Access Compliance Report Public Rights-of-Way (Curb Ramps)

Main Street: N/A Cross Street: LINCOLN_AVE Location: NW

ADA ID: RPAT220127115547 Ramp Type: Type 7 - Directional 2 Initial Pass/Fail: Fail Overall Compliance: No Severity Score: 2

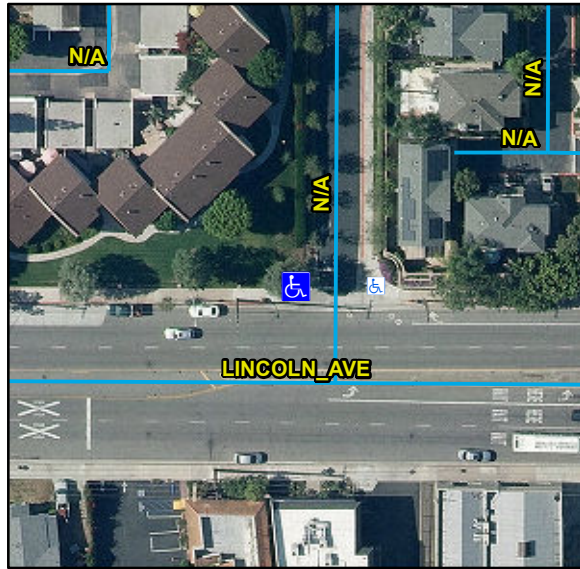
Compliance	Description	Data	Compliance	Description	Data
N/A	Ramp Length (in)	118	N/A	Flare Type LT	
Yes	Ramp Width (in)	82			None
Yes	Ramp Run Slope (%)	7.5	N/A	Flare Slope LT (%)	N/A
No	Ramp Cross Slope (%)	2.2	N/A	Flare Traversable LT	N/A
N/A	Grade Break	Yes	N/A	Flare Type RT	
N/A	Grade Break Slope (%)	0			Curbed2
N/A	Grade Break Cross Slope (%)	0.9	N/A	Flare Slope RT (%)	N/A
	Addl Para Ramp Left?	No	N/A	Flare Traversable RT	N/A
	Addl Para Ramp Right?	No	N/A	DWS Provided	Yes
N/A	Landing Present	No	N/A	DWS Contrast	Yes
N/A	Landing Length (in)	N/A	N/A	DWS Length (in)	41
N/A	Landing Width (in)	N/A	N/A	DWS Full Width	Yes
N/A	Landing Run Slope (%)	N/A		DWS Offset Type	Single
N/A	Landing Cross Slope (%)	N/A	N/A	DWS Left Offset (in)	0
N/A	Landing Movement Obstructed?	No	N/A	DWS Right Offset (in)	N/A
	Landing Movement Type	N/A			
N/A	Landing Shared	N/A			
N/A	Marked Crosswalk 1	No	N/A	Clear Space	N/A
	Crossing 1 Direction	E	N/A	Clear Space To Crosswalk (in)	N/A

Marked Crosswalk 1 Width (in)	N/A			
N/A	Ramp Inside Crosswalk 1	N/A			
	Crossing 1 Slope (%)	0.7			
	Crossing 1 Cross Slope (%)	0			
N/A	Gutter Ponding	No	N/A	Curb Slope	12.2
Yes	Gutter Lip Height (in)	0		Road Run Slope (%)	N/A
N/A	Gutter Run Slope (%)	0.7		Road Cross Slope (%)	N/A
N/A	Gutter Cross Slope (%)	5.4		Parallel Ramp Side	Right
Yes	Overall Surface Condition	Acceptable	Yes	Perp Joint Present	Yes
	Cross Gutter Present?	Yes		Spandrel Present?	Yes
	Replace Cross Gutter?	No		Replace Spandrel?	No

Remove & Replace Entire Ramp.

R304.5.3, STD 1115
